PLANNING DIRECTOR'S SPECIAL PERMIT

APPLICATION: Planning Director's Special Permit for deep lot development (P88-145)

LOCATION: 5615 Wallace Avenue

PROPOSAL: The applicant is requesting the necessary entitlements to construct three single family residences on one deep lot.

STAFF'S REVISED SITE PLAN

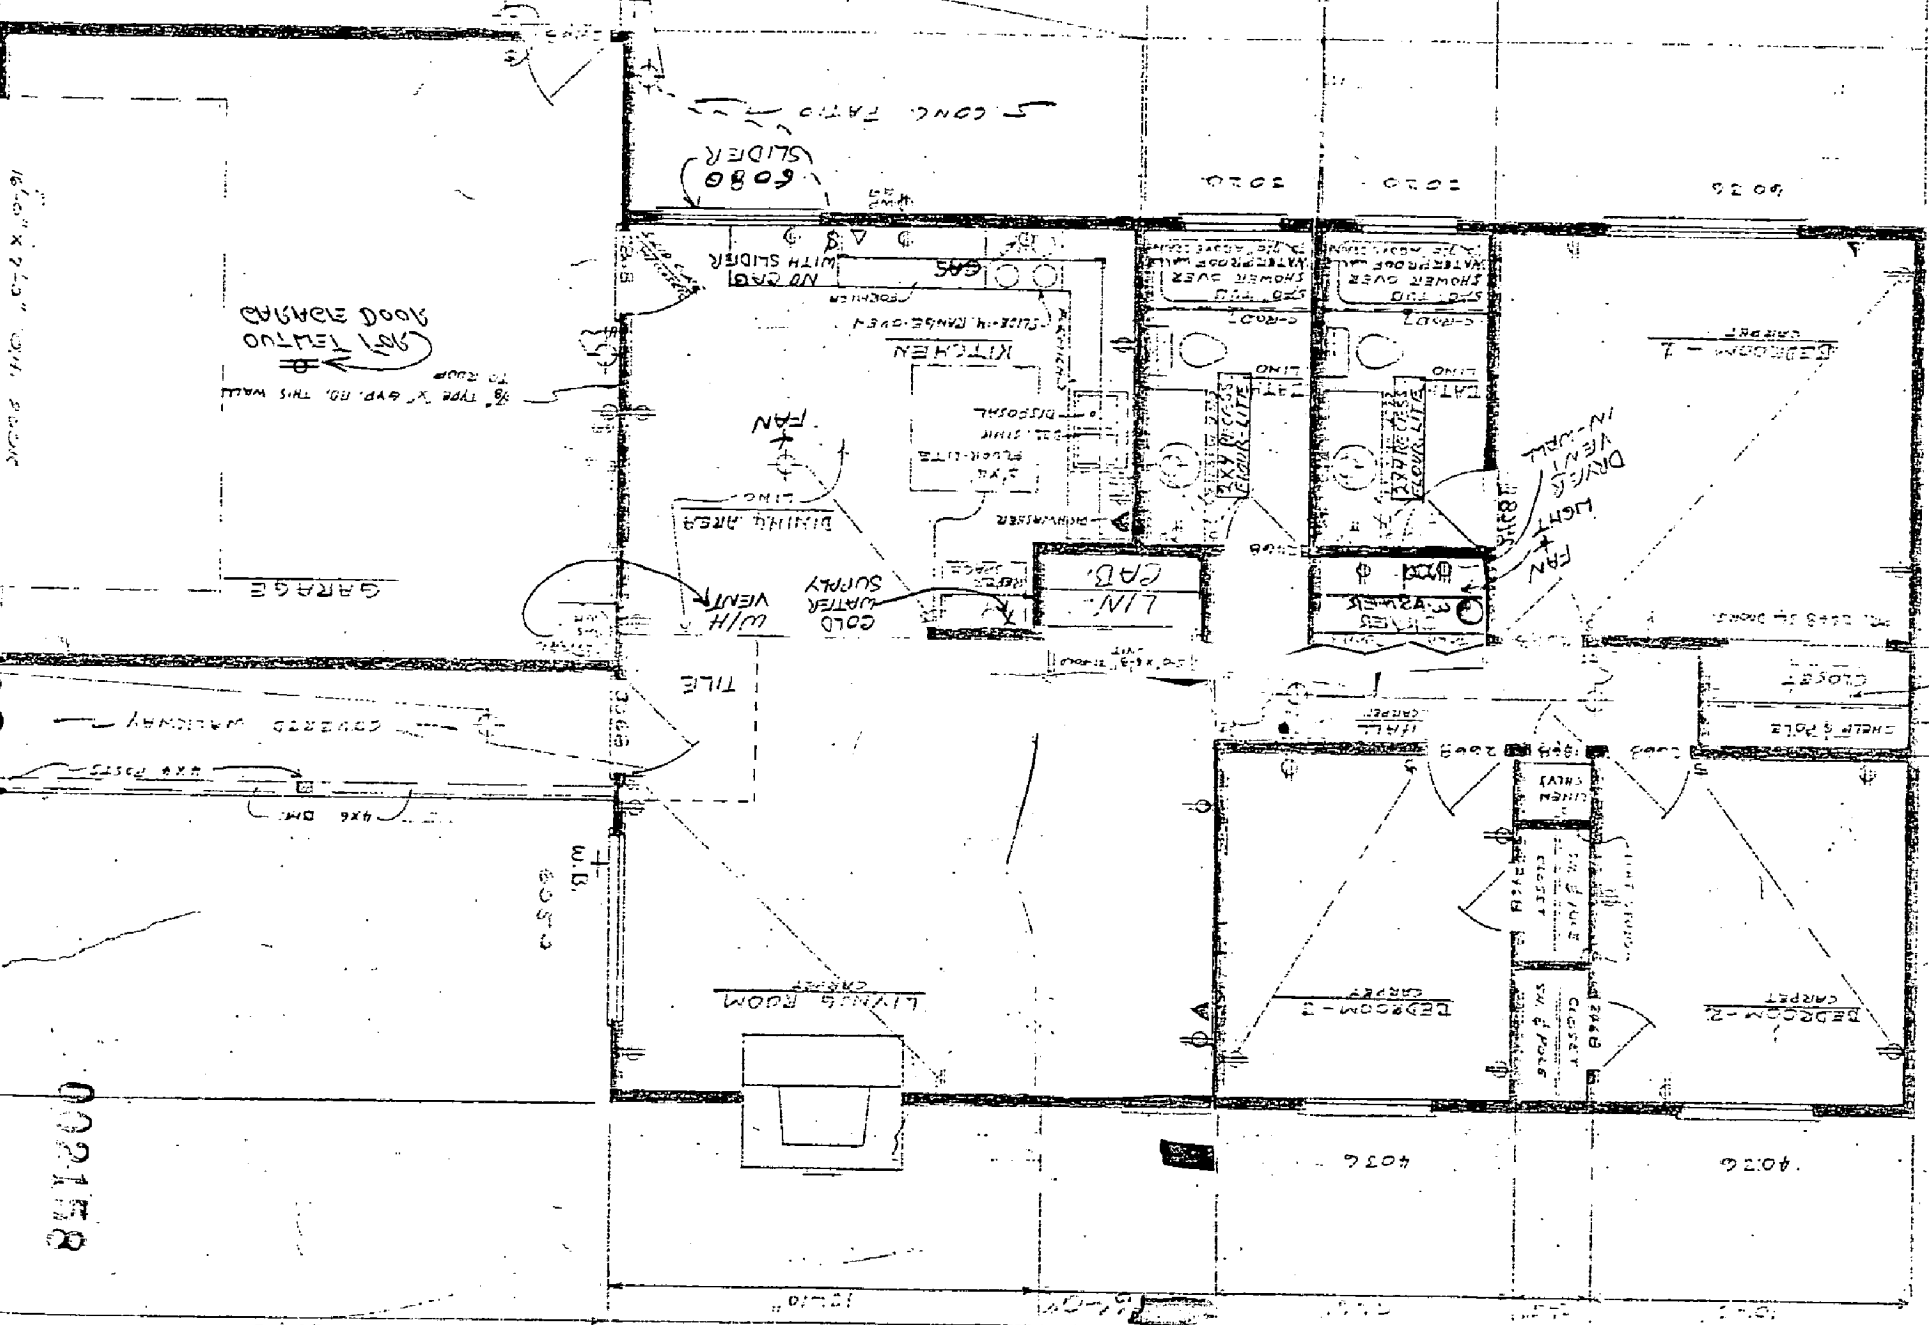
Staff recommends an alternative to the site plan design that will improve the overall appearance of the project. These revisions include re-orienting the rear building in order to achieve the single family residential intent of the deep lot provisions. See the revised site plan.

The major revision would be to the rear unit. If this rear unit is re-oriented to the face or front in a westerly direction, the visual length of the driveway can be decreased and the attractive elevation of the unit can be appreciated. In the proposed site plan, the rear unit's front is not visible without driving to the end of the driveway. Staff's alternative also calls for a minimum 3' planter running along the length of the driveway. This 3' planter will be located between the driveway and the fence which will extend the length of the property line. Staff suggests climbing vines be utilized in planter along the fence line. Small shrubs may also be used. Staff recommends the applicant submit final site and landscape plans for review and approval prior to issuance of building permits.

1. Applicant shall comply with all requirements of Deep lot/Infill regulations (Sec. 9) of the Zoning Ordinance.
2. The driveway shall meet the requirements of the Traffic Engineer.
3. The applicant shall submit revised final site plans to include re-orienting the rear building to face Wallace Avenue and location of a 3' planter along the driveway. These revised plans shall be submitted to the Planning Director for review and approval prior to issuance of building permits.
4. The applicant shall submit final elevation plans to the Planning Director for review and approval prior to issuance of building permits.
5. The applicant shall submit a detailed landscape/irrigation plan to staff for review and approval prior to issuance of building permits.

FRONT UNIT ELEVATION

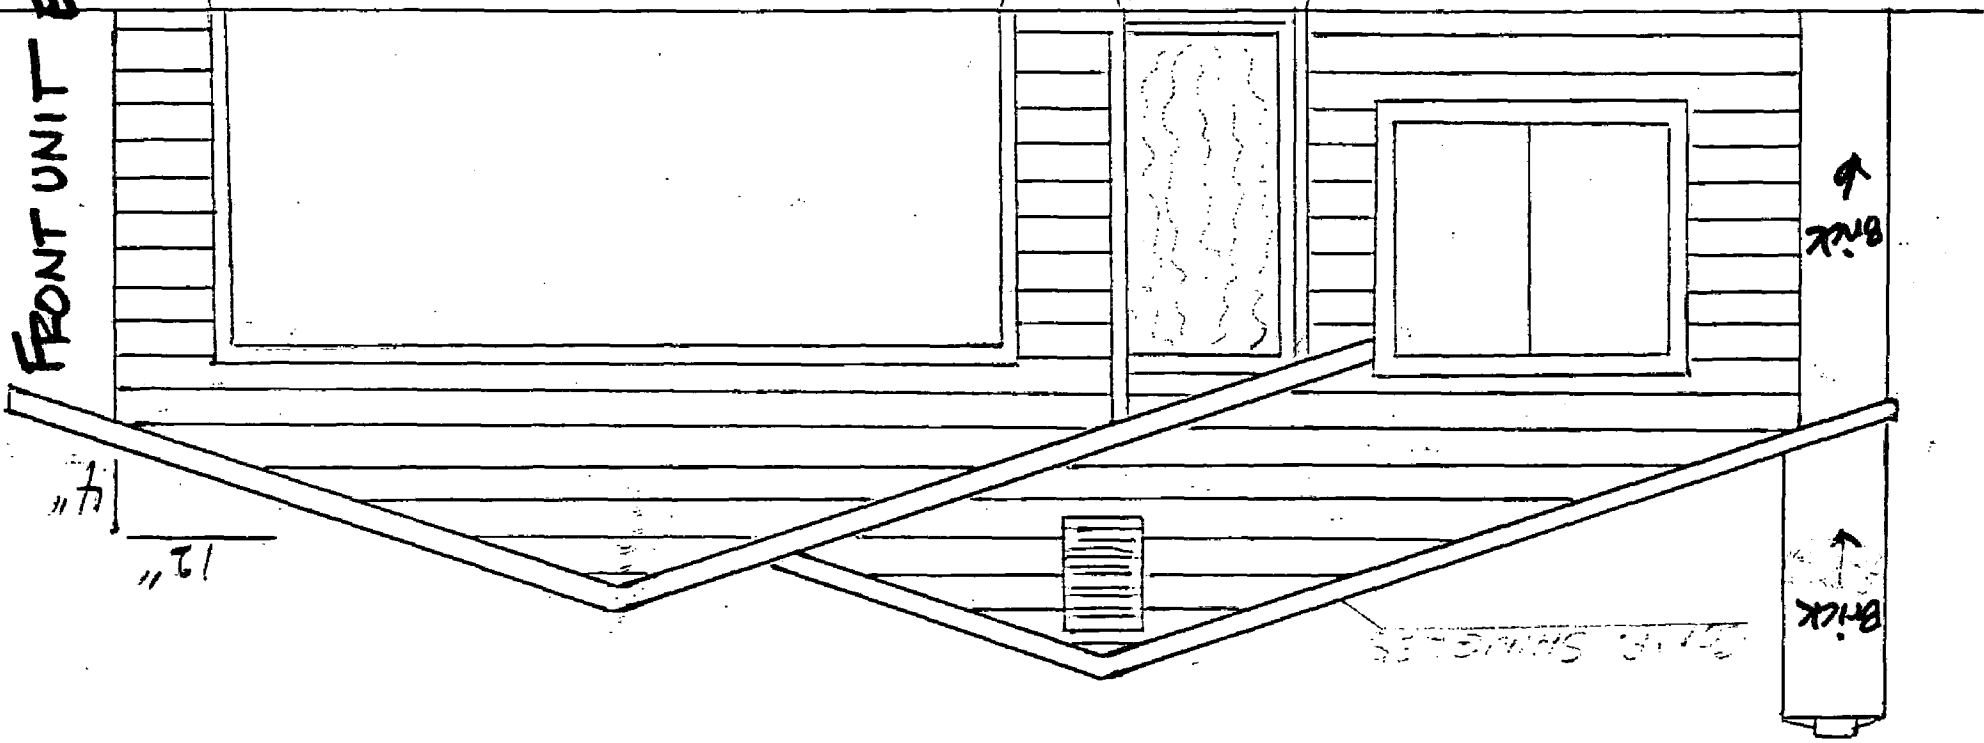
Staff generally finds the building elevations appropriate and that the exterior building materials should compliment the surrounding area. The applicant has submitted two different elevation plans for the two rear units. Staff recommends elevation A-1 for the middle unit and elevation A for the rear unit. Staff also recommends the applicant use a type of composition shingle that is thick which can give the appearance of wood shakes. The front unit should utilize the attached elevation B which consists of horizontal wood siding and a brick fireplace.
